00 91 00 – ADDENDUM NO. 2

Date: October 18, 2018
Project Name: Chlorination System Improvements Water Treatment Plant
Project No.: VRNTL-18-8-08
BMCD Project No.: 104587

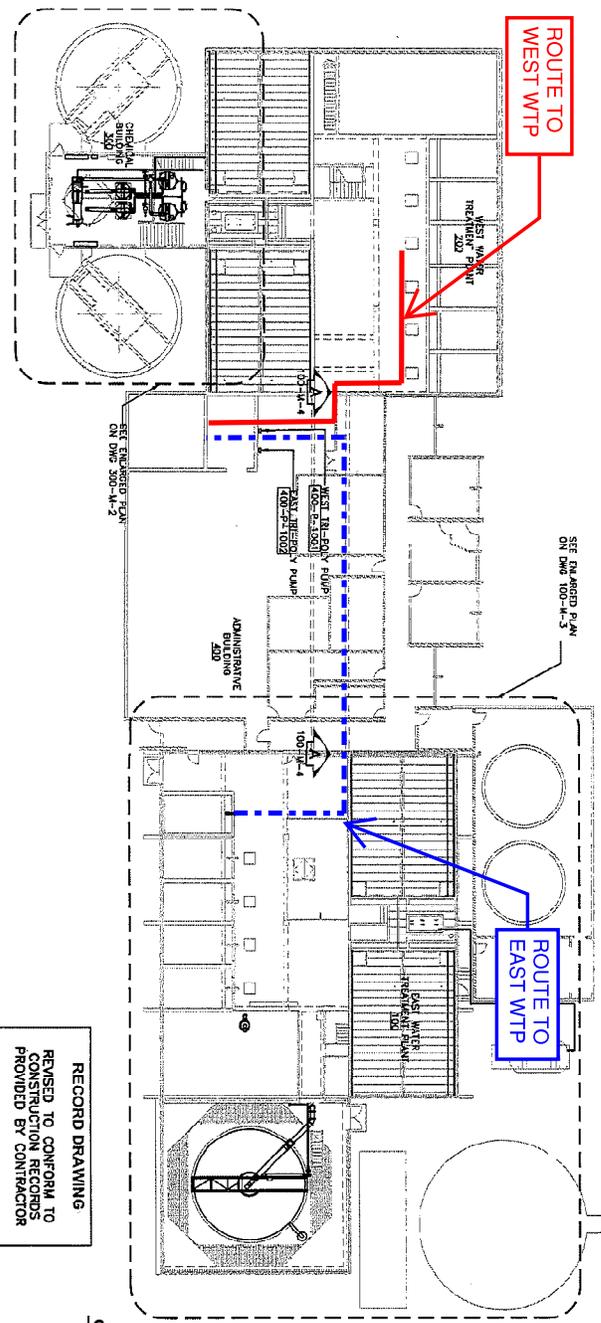
7. *How much piping is required to connect to the East and West Treatment plants?*

Response: Connection to the West WTP will require approximately 160 feet of CPVC piping. Connection to the East WTP will require approximately 240 feet of CPVC piping. Please refer to the attached record drawing for general routing.
